## Report sheet appusbcar

### -Appusbcar 1Port:

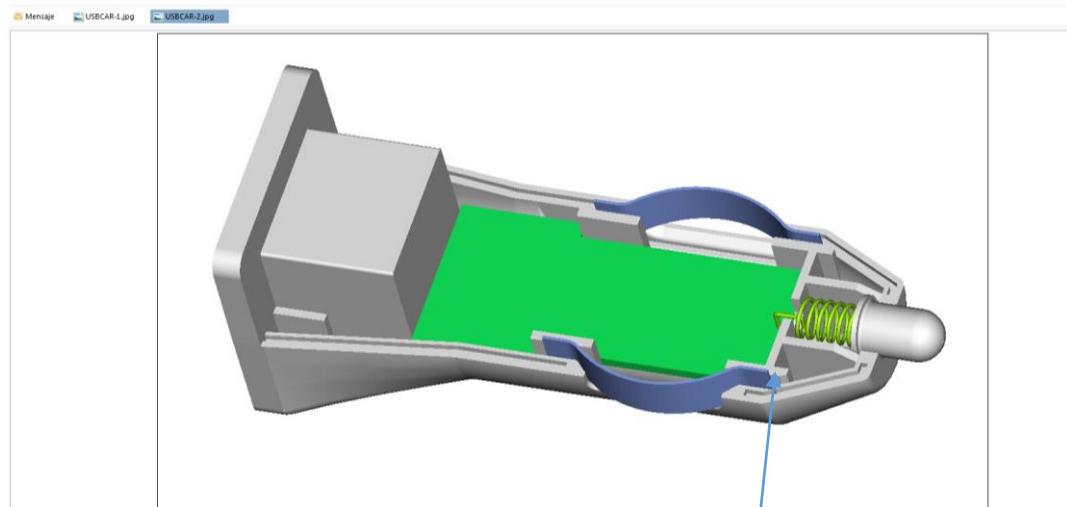
1. Problem. The metal lateral contact does not fix with the housing correctly.

Look:

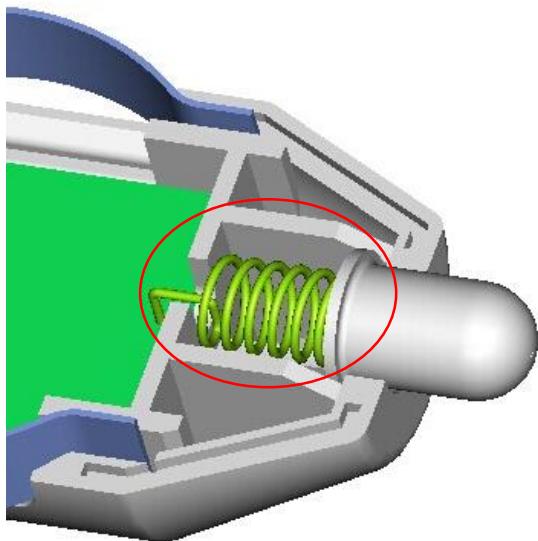
The lateral metal contact fix in the housing for this system. In the mocke up this system doesn't exist.

Please solve this problem, it's dangerous if it make short circuit.

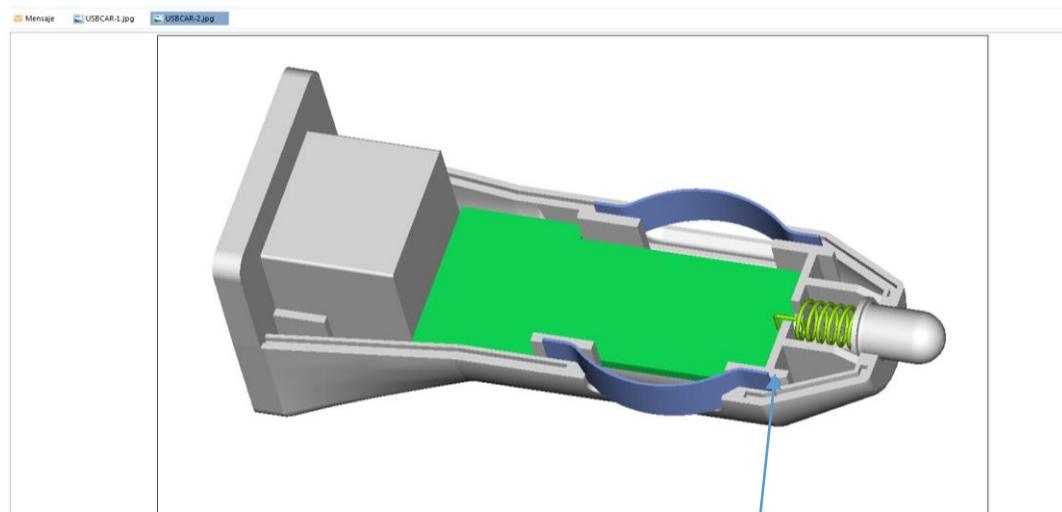
3. The led is circular, but it should be rectangular for it can introduce in the led hole.  
OK?

As the led of this picture.

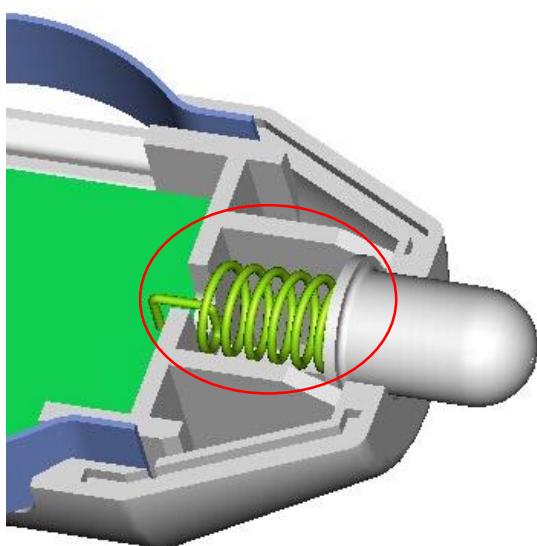
1. Problem. The metal lateral contact does not fix with the housing correctly.

The lateral metal contact fix in the housing for this system. In the mocke up this system doesn't exist.

Please solve this problem, it's dangerous if it make short circuit.
